TOWN OF CARMEL PLANNING BOARD

# PLANNING BOARD AGENDA SEPTEMBER 16, 2020 – 7:00 P.M.

Re: Site Plan Lantern Pub Reconstruction 728 Route 6, LLC 728 Route 6, Mahopac TM # 76.22-1-54

The below is a response to comments from the Town Consultants and Staff as follows:

JOHN KARELL,	JR. P.	<b>=</b> .
121 CUSHMAN ROAD PATTERSON, NEW YORK	12563	845-878-7894 phone 845-878-4939 fax jack4911@yahoo.com
728 ROUTE 6 LLC 728 ROUTE 6	SCALE: 1" = 20'	LATEST REVISION
CARMEL (T)	DATED: AUGUST 17, 2020	SHEET No
SITE PLAN	TAX MAP 76.22-1-54	S-1

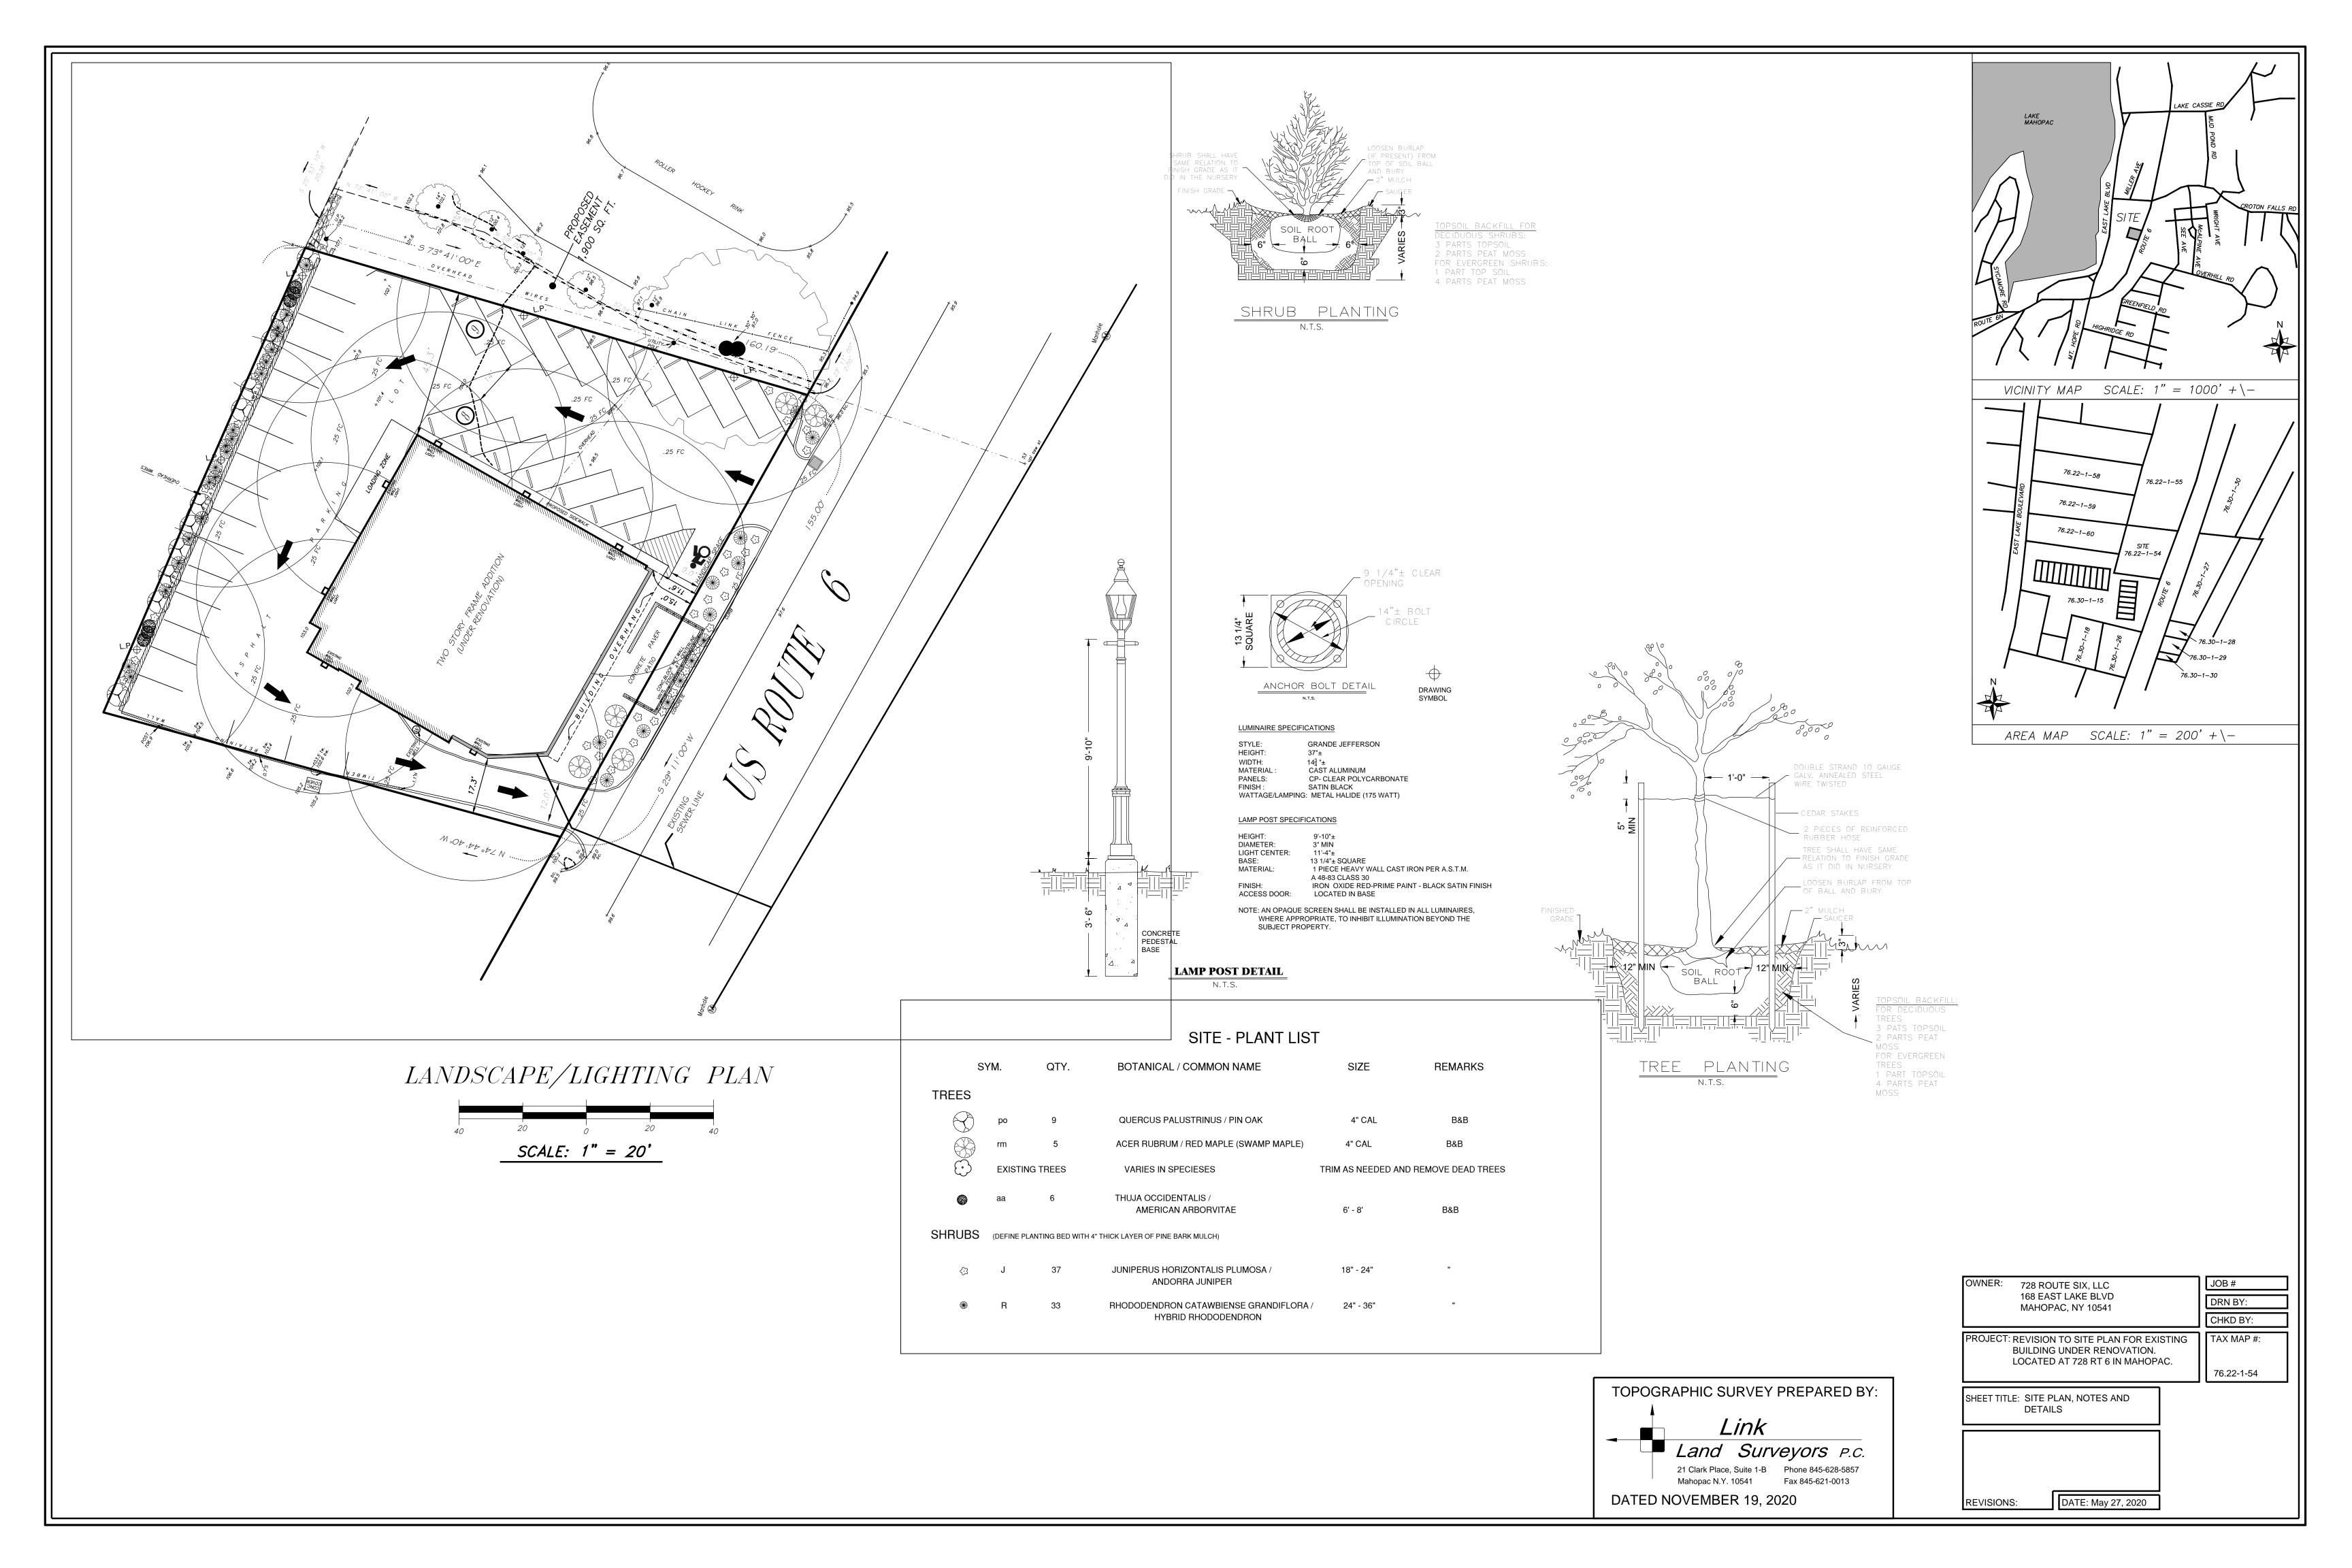
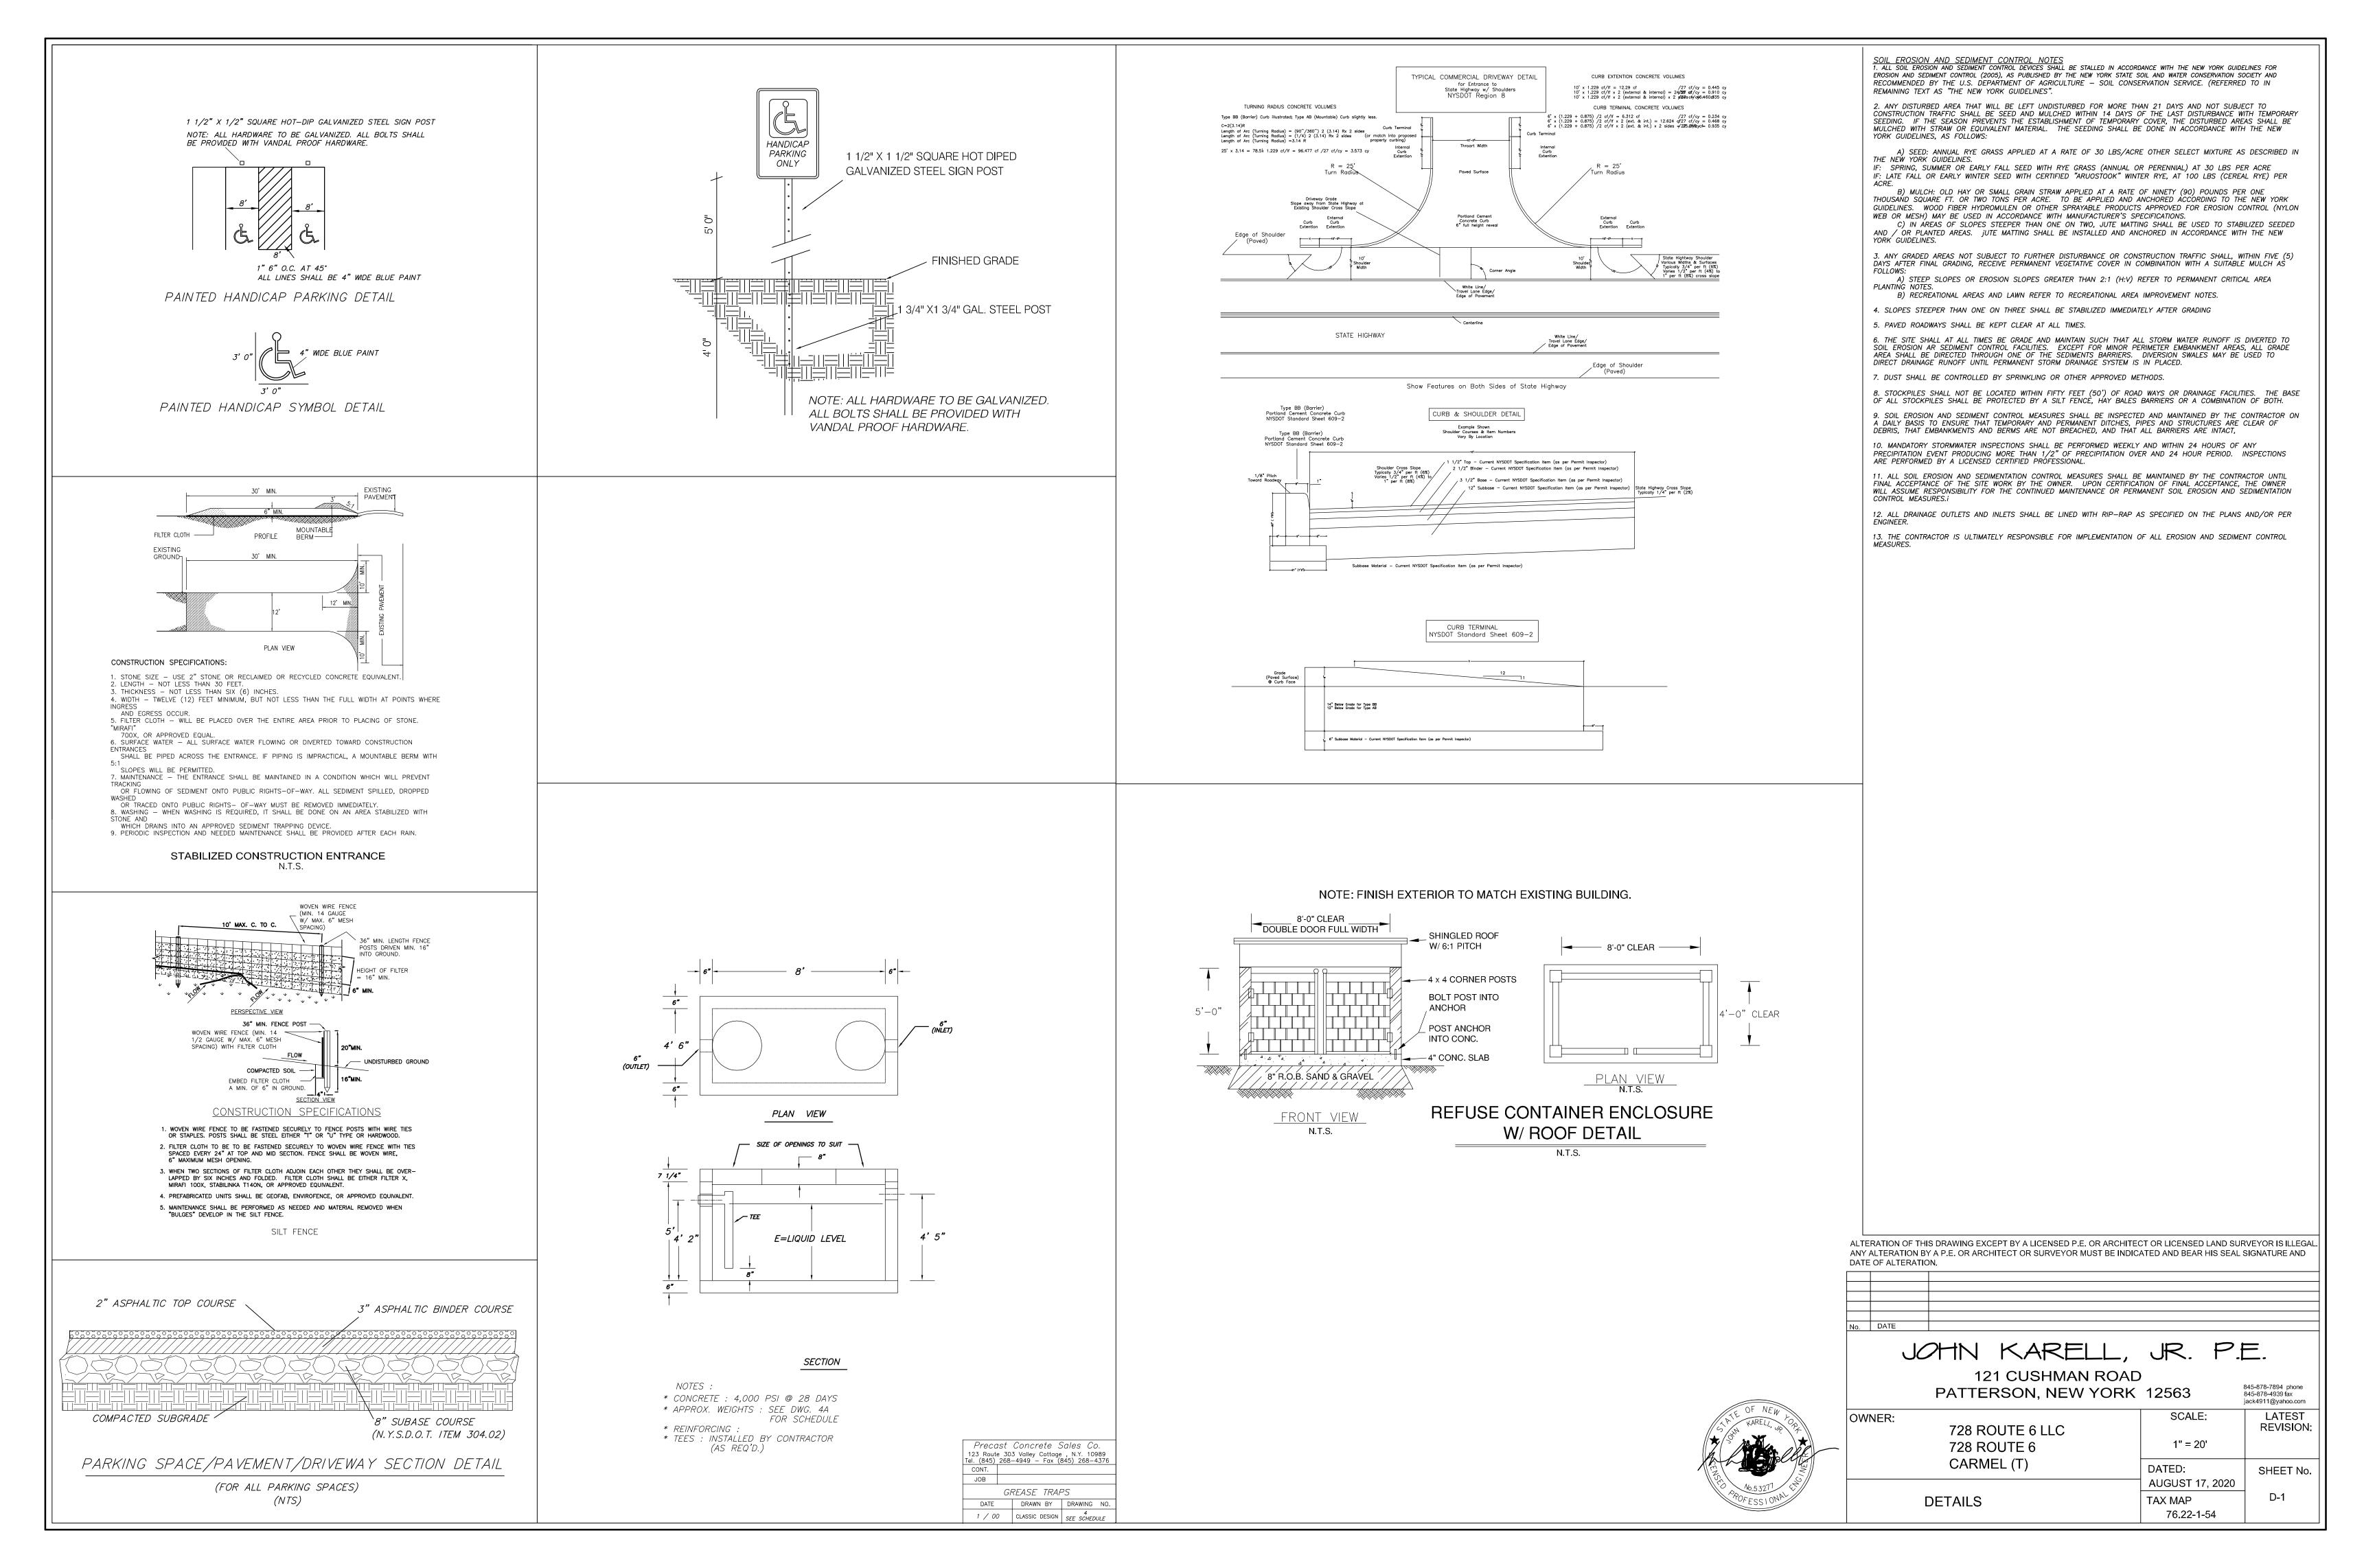
## Michael Carnazza, Building Inspector and Zoning Code Administrator dated July 13, 2020

# Pat Cleary, Planning Consultant, dated July 15, 2020

### Richard Franzetti, P.E., Town Engineer dated July 13, 2020

- 1. The second floor is proposed for 1000 square feet of office space, not dry storage.
- 2. Previous variances that were issued by the Town have been noted on the plans.
- 3. The aisle width has been dimensioned.
- 4. Two development scenarios have been shown on the plans, with and without the School easement. The easement is under consideration by the School District. It is noted that the easement provides for a wider aisle width.

- 1. See item # 1 above relative to the use of the second floor.
- 2. The required parking spaces are shown on the plan and in a table for each use, including the second floor office.
- 3. The coffee shop will be takeout with no seating. The use has been identified and parking reqirements have been revised.
- 4. The parking spaces will be striped.
- 5. Refuse and recycling areas are identified and detailed.
- 6. The existing fenced in area will continue to be utilized for outdoor seating. DOT has been contacted and their determination will be provided to the Board upon receipt.
- 7. The paved area to the south of the fenced in area will be removed and landscaped.
- 8. Landscaping is proposed on the plans for the rear and north property lines.
- 9. New pavement will be provided over the entire driveway and parking areas.
- 10. Exterior lighting is proposed as shown on the plans.

- 1. Noted
- 2. Noted relative to approvals required.
- 3. A trip study is attached.
- 4. Vehicle Movement

Turning Radii is shown

Type of traffic is contained in the study.

- 5. DOT has been contacted for permitting requirements
- 6. Employee information is provided. Parking requirements have been identified in a table on the plans.

- 7. Grease Trap Calculations are provided.
- 8. Landscaping for the rear and north property lines are shown.
- 9. Noted relative to verification by the Wetlands Inspector.

- 10. Plantings are believed to be in accordance with Section 142 of the Town code.
- 11. It is believed that the curbing and asphalt pavement are in accordance with Town Code.

- 12. Sidewalks, manhols and guiderails per section 128
- 13. Water and sewer use reports are provided. Water usage will be the same as sewage discharge.

- 14. A legend is provided.
- 15. No sign is proposed at this time..
- 16. No new drainage is proposed. The existing drainage patterns will be maintained. It is noted that the site drains from the rear to Route 6. No problems with this drainage pattern are evident.

- 17. Garbage enclosuredetails are provided.
- 18. Lighting details are provided on the plans
- 19. The existing retaining wall on the south side o the building has been repaired.

20. No public improvements are proposed.
